Project	IEEE 802.16 Broadband Wireless Access Working Group < <a href="http://ieee802.org/16">http://ieee802.org/16</a> >	
Title	Cell Search for Cellular Operation of 802.16 OFDMA	
Date Submitted	2004-08-17	
Source(s)	<p>Sang Woo, Hwang hanarotelecom</p> <p>Jin-Woo Lee and Yong-Hwan Lee Seoul National University Kwanak P. O. Box 34, Seoul, 151-600 Korea</p>	<p>Voice: +82-2-6266-2863 Fax : +82-2-6266-5309 mailto: hsww@hanaro.com</p> <p>Voice: +82-2-880-8413 Fax : +82-2-880-8213 mailto: ylee@snu.ac.kr</p>
Re:		
Abstract	This document contains a new downlink preamble structure for cell search that provides fast performance with low computational complexity in cellular operation of 802.16 OFDMA.	
Purpose	To propose a new downlink preamble and cell search scheme for cellular operation of 802.16 OFDMA	
Notice	This document has been prepared to assist IEEE 802.16. It is offered as a basis for discussion and is not binding on the contributing individual(s) or organization(s). The material in this document is subject to change in form and content after further study. The contributor(s) reserve(s) the right to add, amend or withdraw material contained herein.

# Cell Search for Cellular Oper

**Figure 1 The proposed DL preamble structure in the time domain**

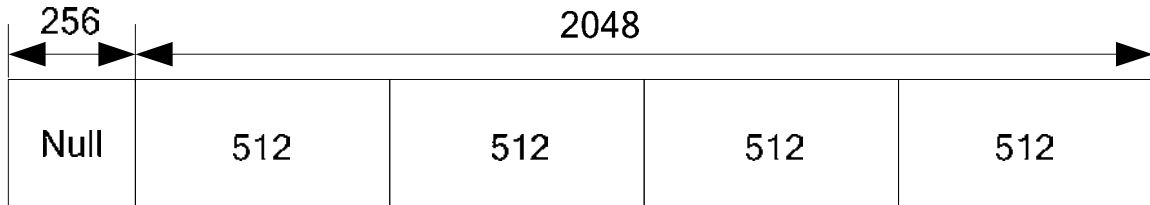
[Replace section 8.4.6.1.1]

The first symbol of each frame in the downlink transmission is the preamble comprising four periods of a signal and a guard interval with zero power in the time domain. A time domain structure of the DL preamble is shown in Figure 1.

128 distinct preamble patterns are used to distinguish a cell (or sector) from others. The preamble can be designed in the frequency domain, which is BPSK modulated as follows,

$$P[k, n_c] = \begin{cases} 2\sqrt{2}q[k/4, n_c], & k = 0, 4, 8, \dots, 2048 \\ 0 & , \textit{otherwise} \end{cases} \quad (1)$$

where  $q[m, n_c]$  is an extended PN sequence of length 512,  $n_c$  denotes the cell code number belonging to  $\{0, 1, 2, \dots, 127\}$ , the number of subcarriers is 2048 and the guard interval has 256 samples. After being processed by inverse discrete Fourier transform (IDFT),  $P[k, n_c]$  has four periods of a signal of length 512 samples in the time domain as depicted in Figure 1. Note that the constant  $2\sqrt{2}$  in (1) is used to make both the DL preamble and OFDMA symbol have the same average power.
